AGENDA ITEM 5A: 808 N Sheridan Ave: New DADU with Garage

APPLICATION FOR DESIGN REVIEW Permit Number: HDR25-0002

Historic Review Initial Feedback Response Letter:

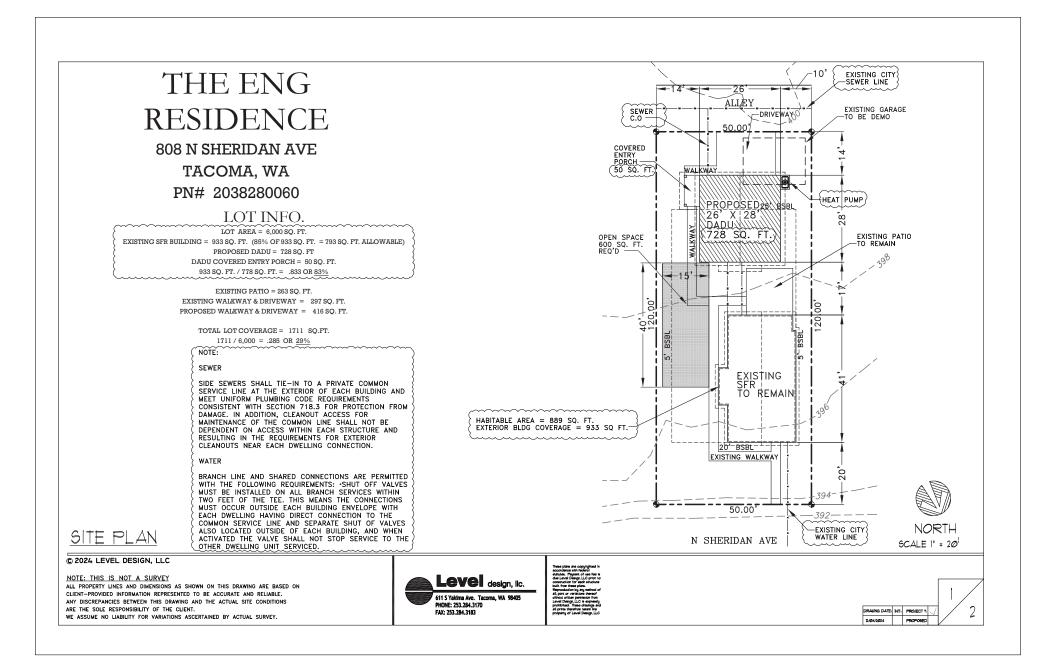
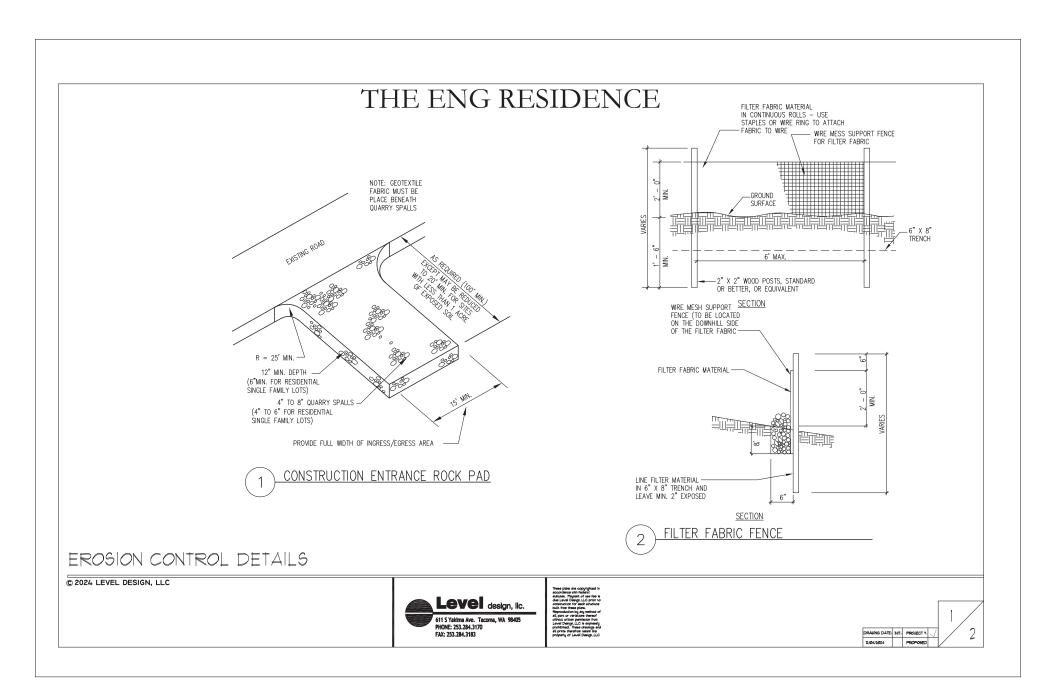
- Windows specification. The Commission did not express a strong preference regarding the Milgard Ultra wood windows or the aluminum clad windows you included in the supplemental. However, the Commission would like to see detail on the grids (such as sections showing how the grids and grid spacers are assembled – detail spec sheets should provide that information)
 - a. Our window supplier is recommending we use an Anderson Fiberglass window. He has used these in historic districts previously and they meet the requirements in the guidelines for this neighborhood. I will attach the spec sheet showing the

grid sections. We need to use the product to meet our energy credit as these are super efficient windows.
